July 25, 2014
Project No. 8128.01.08

Re: *Revised* Monitoring Wells WS-11 and WS-14 Abandonment Plan
Siltronic Corporation
7200 NW Front Avenue, Portland, OR
ECSI No. 183

Re: WS-11 and WS-14 Well Abandonment—Response to DEQ email dated 6/25/14
Siltronic Corporation
7200 NW Front Avenue, Portland, OR
ECSI #183

Figure 2-3c
Geologic Cross Section A-A'

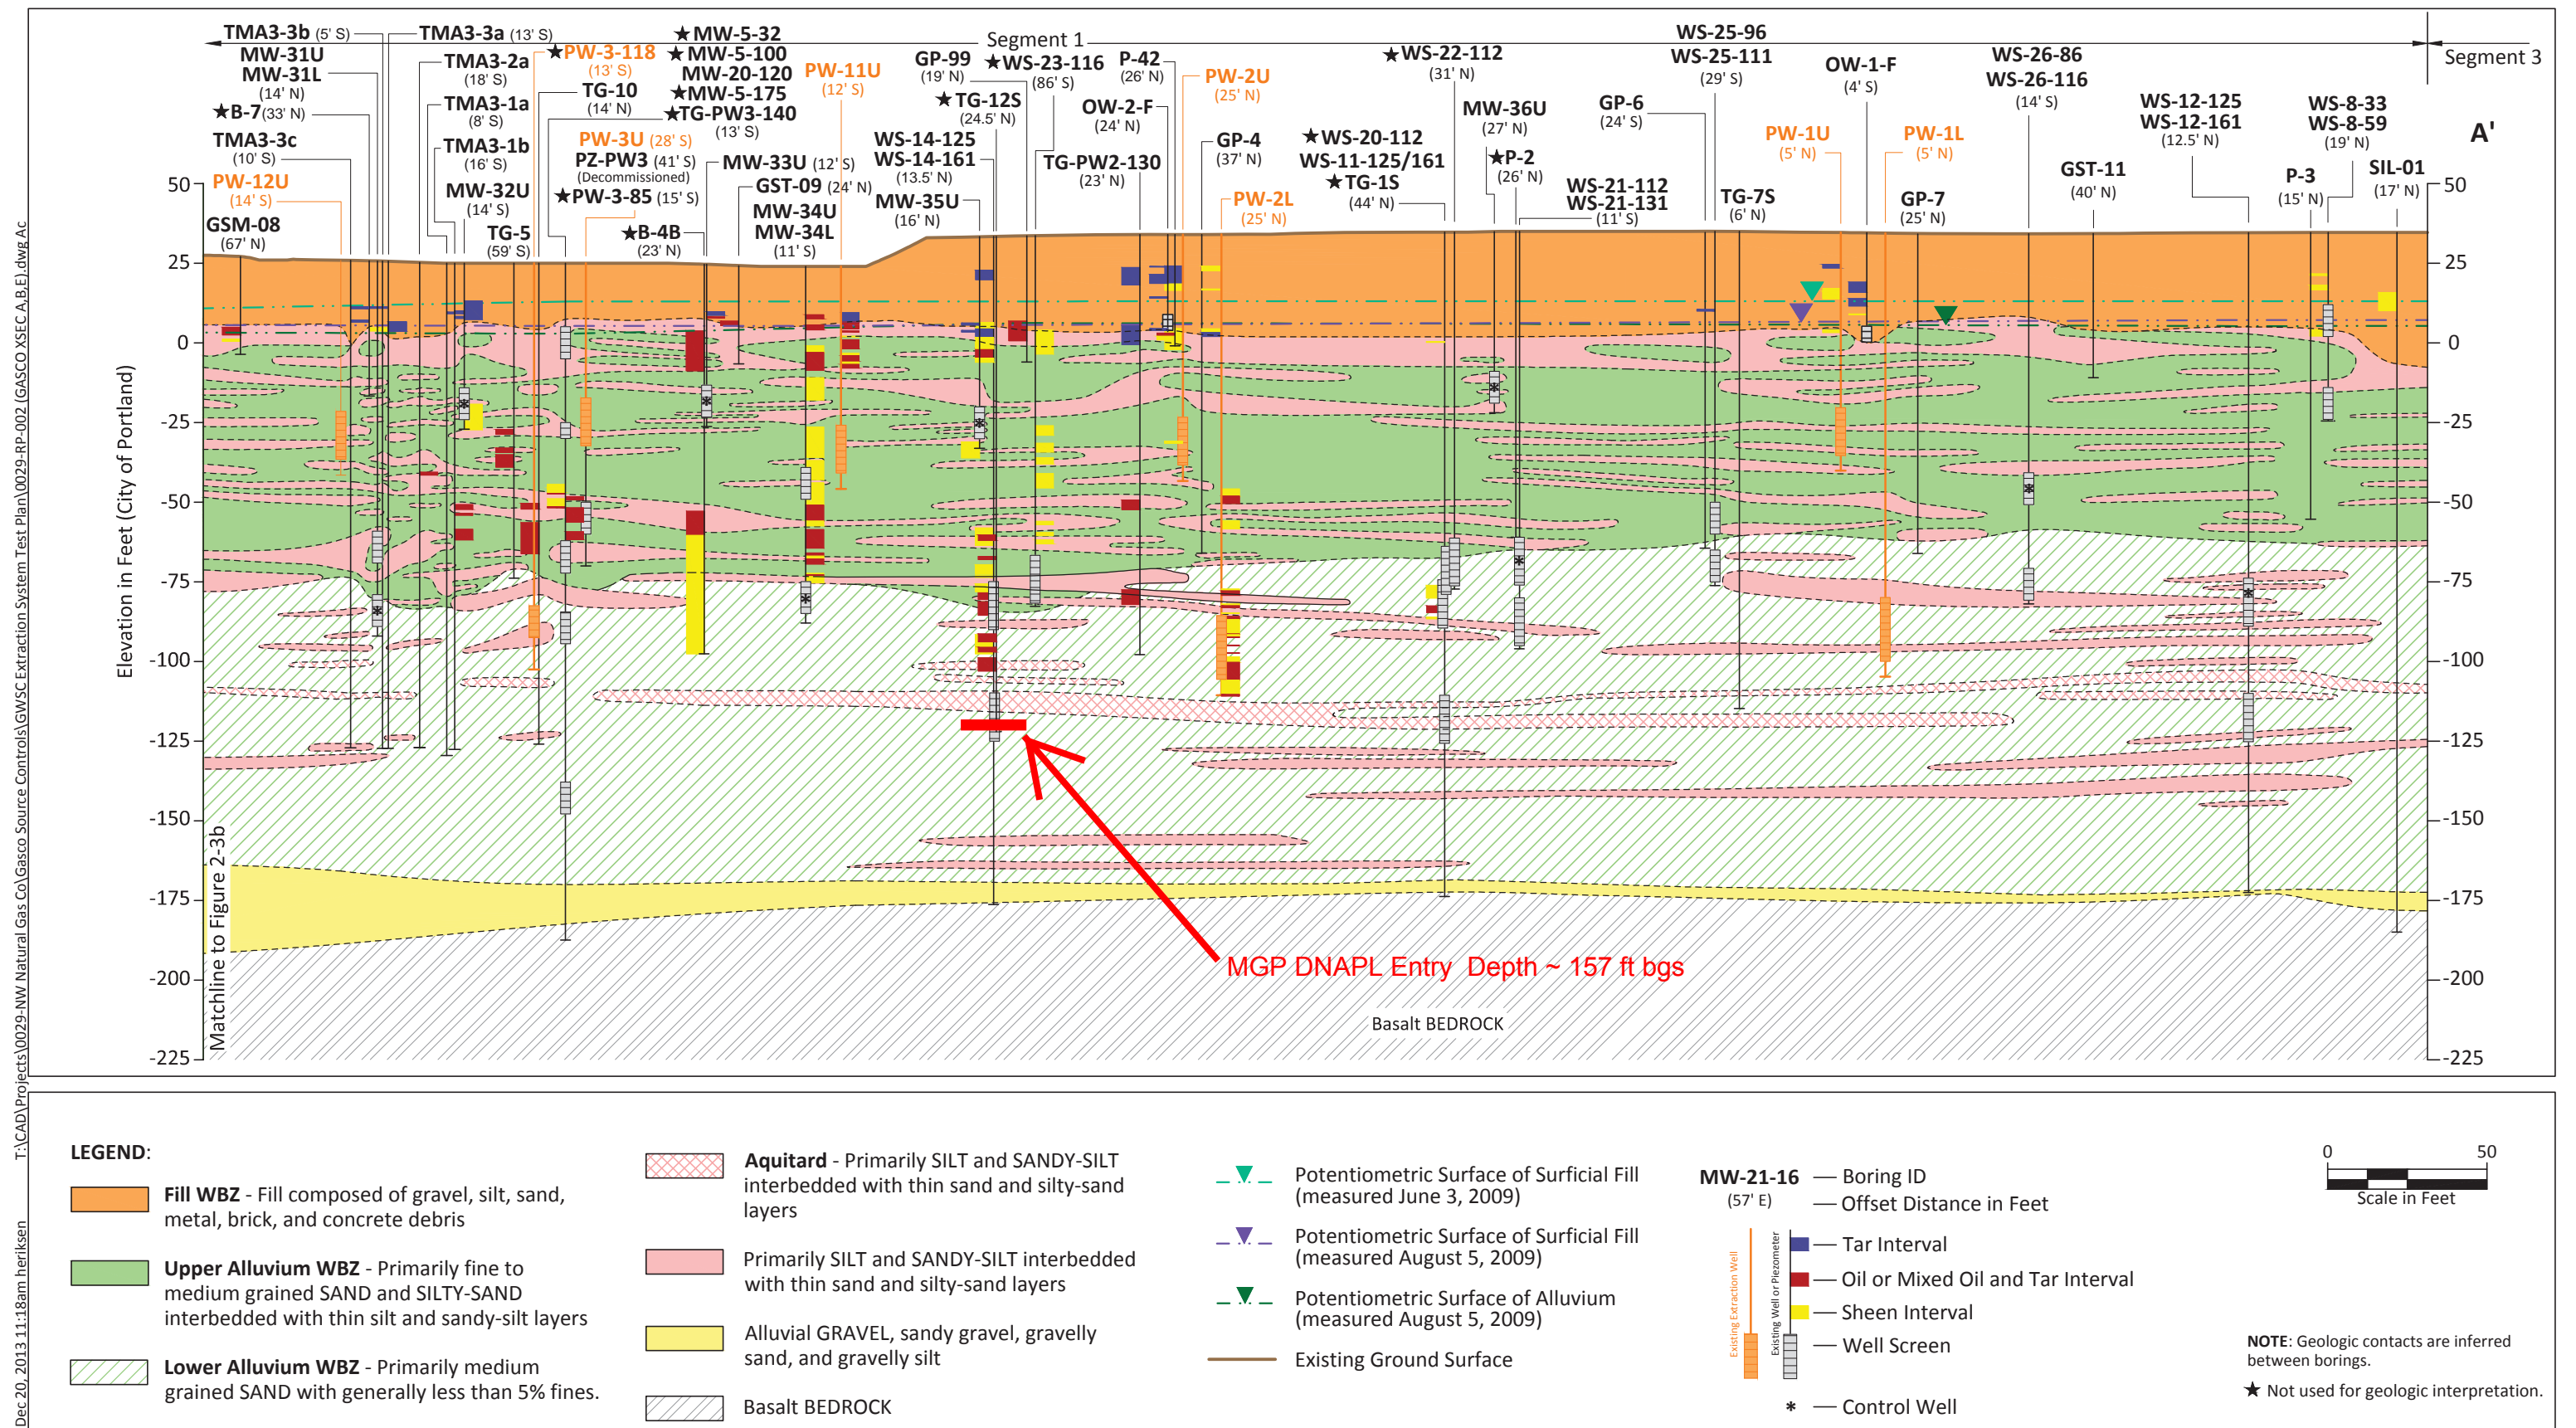
- 1) DEQ and Northwest Natural (NWN) have developed a conceptual site model (CSM) that posits an aquitard separating the ULA and DLA (as shown on Figure 2-3c¹, which is attached for reference). That putative aquitard supposedly influences groundwater elevations measured during the hydraulic control and containment (HC/C) system testing phases, and has been incorporated into the HC/C system model to facilitate corroboration of the measured and predicted results. However, it has not been demonstrated that this aquitard is laterally continuous such that it prevents downward flow of groundwater, or that it results in complete hydraulic separation (characteristic of an aquiclude) of the alluvium water bearing zone (AWBZ) into distinct subunits. In contrast, data collected during the remedial investigations of the Siltronic site demonstrate that the DLA is already impacted by

¹ The figure notes that geologic contacts are inferred between borings. The geologic contacts inferred for the aquitard are extended between WS-14 and WS-11 (approximately 150 feet distant) with no intermediate borings shown. The aquitard contacts are further extended laterally toward the MW-5 location, again with no intermediate borings shown. There is no lithologic data presented to support the extent or continuity of the aquitard.
